# CITY OF SAN ANTONIO

Re: High Chaparral

POADP # 699

# PRELIMINARY OVERALL AREA DEVELOPMENT PLAN

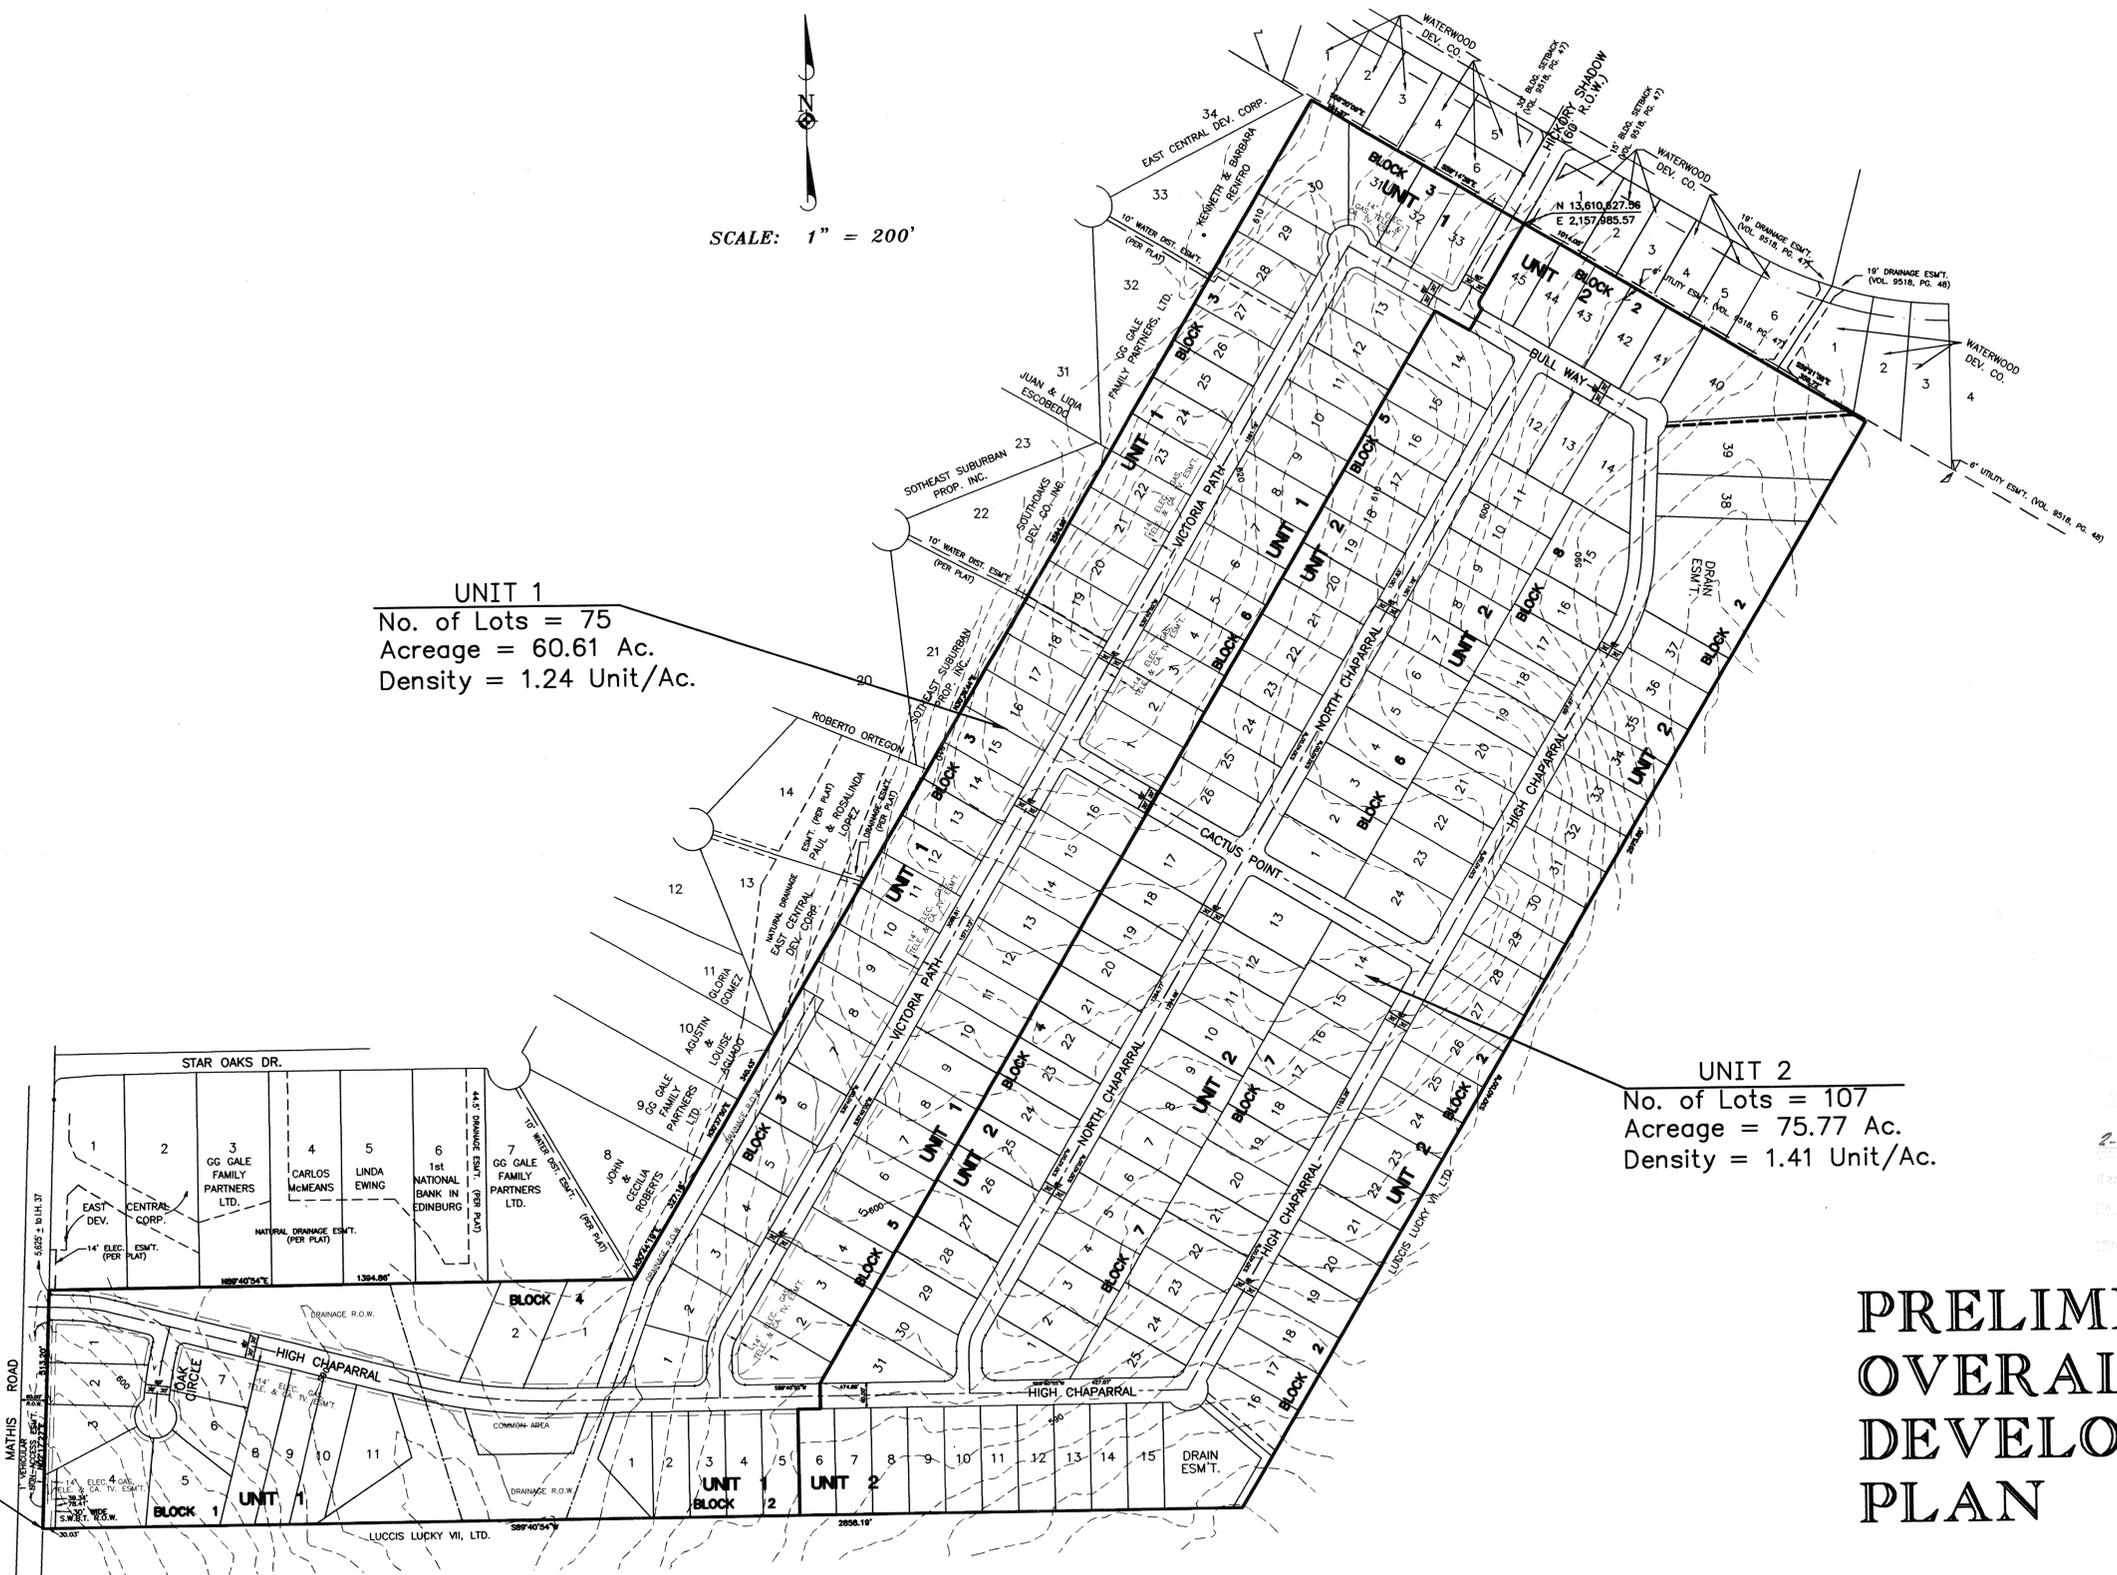
- Based on the topography, a Flood Plain Study and drainage review will probably be required during the platting process.
- This development will need to comply with tree preservation ordinance #85262. For information about these requirements you can contact Building Inspections at 207-7102.
- It will be expected that you will plat all of the property depicted in your POADP, to include: floodpains, drainage areas and open space.
- I would encourage you to work closely with the school district, so that they can plan accordingly.
